**Review and Evaluation of
Dogwood Corners, LLC
Siting Assessment Report
Case Number: 2023-00246**

January 12, 2024

Kentucky State Board on Electrical Generation and Transmission Siting
211 Sower Blvd.
P.O. Box 615
Frankfort, Kentucky 40602

BBC Research & Consulting
1999 Broadway, Suite 2200
Denver, Colorado 80202-9750
303.321.2547 fax 303.399.0448
www.bbcresearch.com

Figure C-2.
Dogwood Corners Preliminary Site Layout

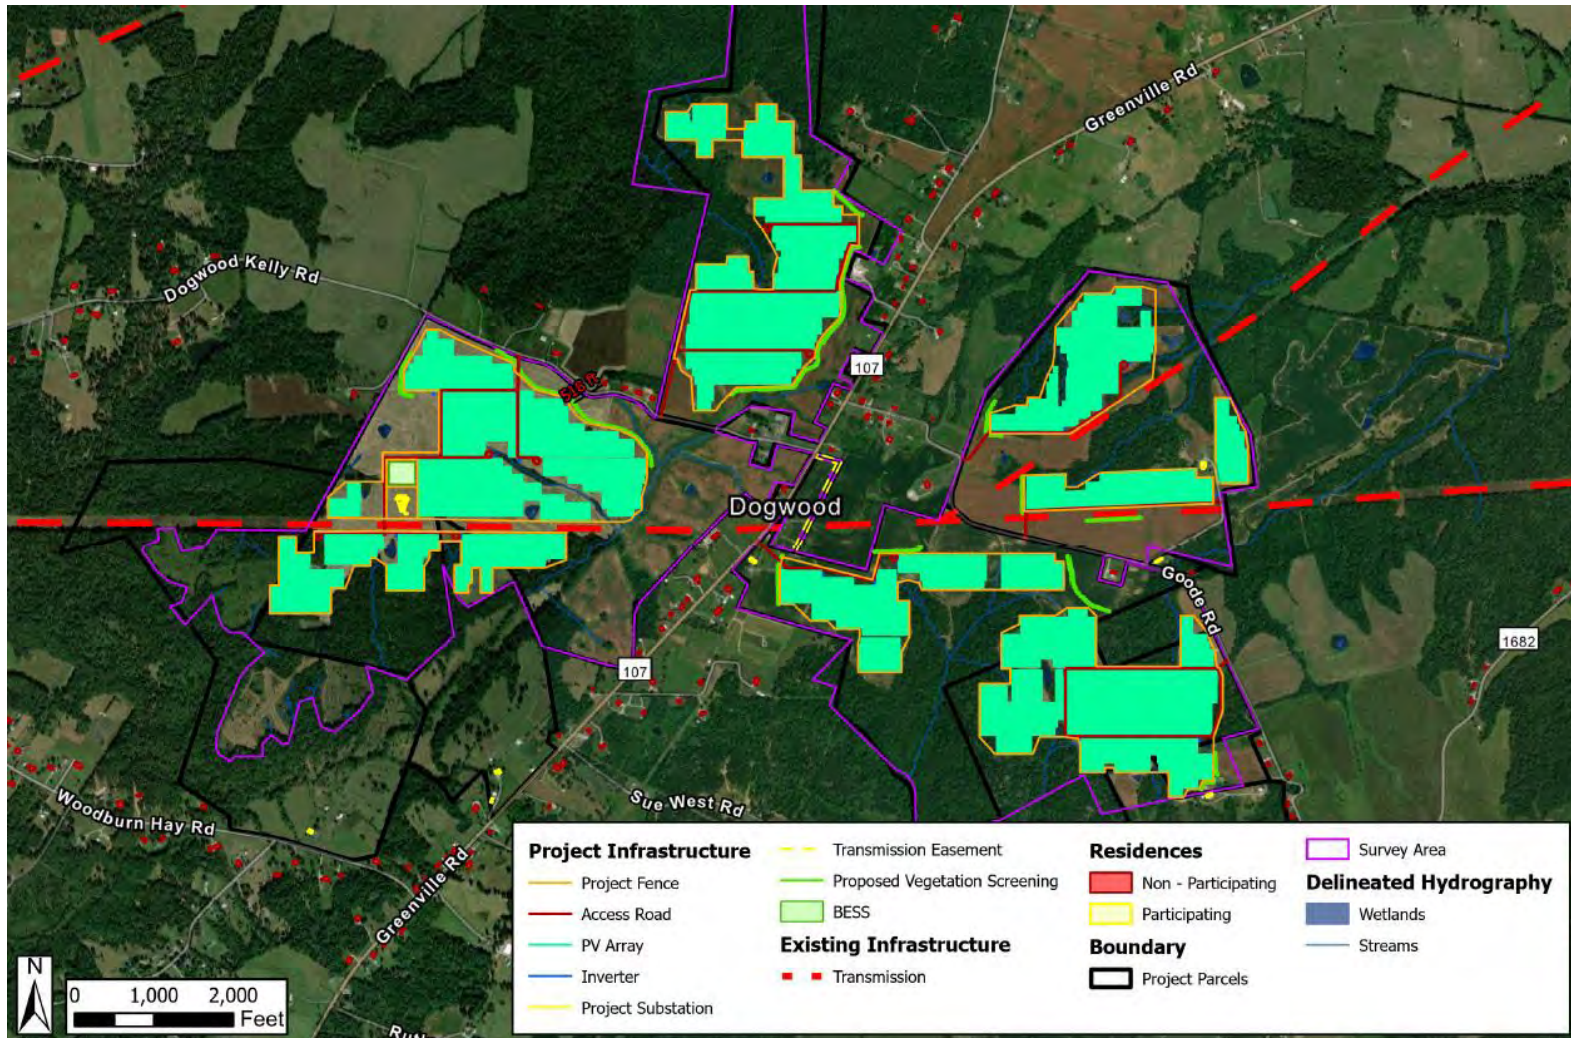
BBC examined Appendix B. These plans depict the proposed substation, BESS, and locations of project components such as fencing, internal access roads, inverters, and solar panels. However, some features of the map were unclear. In the Siting Board's First RFI, the applicant was requested to provide an updated site layout map identifying specific additional features of the proposed project.

BBC confirmed there are no railways in the vicinity of the site. The preliminary site layout depicts internal roads to provide access to project components such as the solar modules but does not show the access points from public roadways or security gates to the site. In the Siting Board's First RFI, the applicant was requested to provide an updated site layout map identifying access points as well as other additional features of the proposed project.

1. Dogwood Corners should provide a final site layout plan to the Siting Board when site design is finalized. Any change in project boundaries or site layout from the information reviewed during this evaluation—including changes to the locations of solar panels, inverters, transformers, the substation, project fencing or other project facilities—should be clearly documented and submitted to the Siting Board for review.

Figure C-6.
Dogwood Corners Preliminary Site Layout

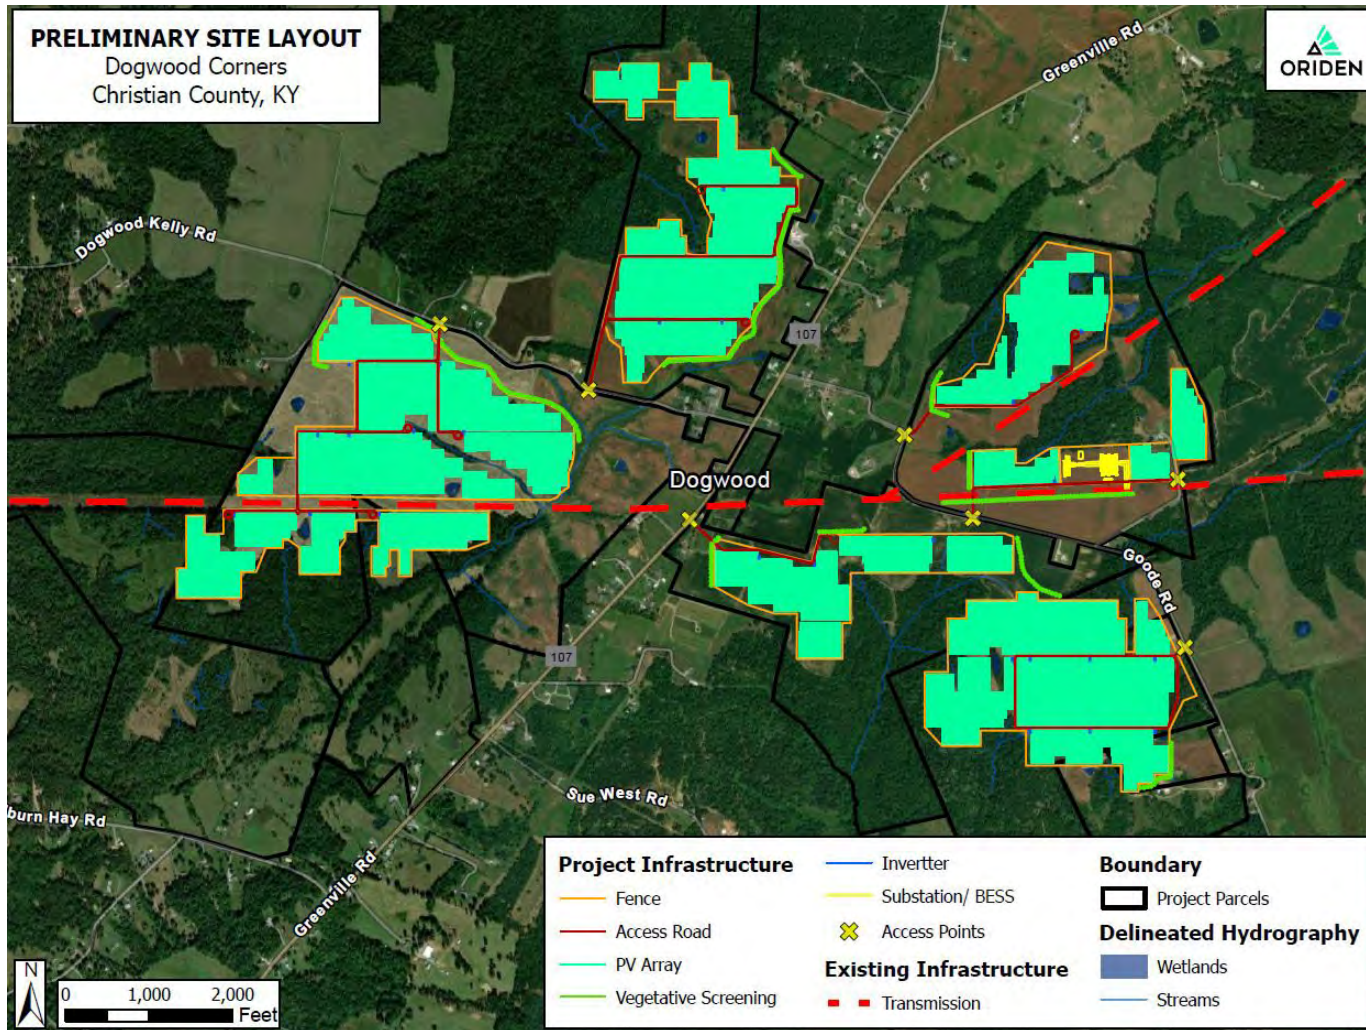
Location of buildings, transmission lines, and other structures. In response to the requests in the Siting Board’s First and Second RFI, Dogwood Corners supplied updated maps of the proposed site layout and locations of project components. The most current update, from the Second RFI, is excerpted below as Figure C-6. Importantly, the applicant has altered the proposed location for the substation and BESS, which are now located in the easternmost pod of solar arrays. Dogwood Corners summarized reasons for this change in their Responses to the Second RFI:

Location and use of access ways, internal roads, and railways. In the Siting Board’s First RFI, the applicant was requested to provide an updated site layout map identifying access points as well as other additional features of the proposed project. Figure C-6 shows seven access points to the site: two on Dogwood Kelly Road, one on Greenville Road, three located on Goode Road and one on Fears Road, which would be the closest access point for the revised substation location.

[...] The new substation location is approximately 1,100 feet away from the closest neighbor. Additional screening is proposed around the substation and an analysis of potential sound impacts shows that the substation will not cause an increase in background noise levels at the closest receptor. Dogwood Corners chose the proposed substation location based on the greatest distance to neighboring landowners while considering the following additional factors. Dogwood Corners attempted to reduce land disturbance and potential impacts to natural resources (such as forested habitat, stream and wetland resources) by choosing a location along the 161kV Hopkinsville-Lost City transmission line, to which the project will connect. This prevents the need for installation of an additional transmission line to connect the project to the 161kV Hopkinsville-Lost City transmission line. Dogwood Corners chose a location near TVA’s preferred location at the intersection of the existing 161kV Hopkinsville-Lost City and 69kv transmission lines. Finally, the substation location requires suitable, relatively flat terrain and favorable geotechnical results.⁹
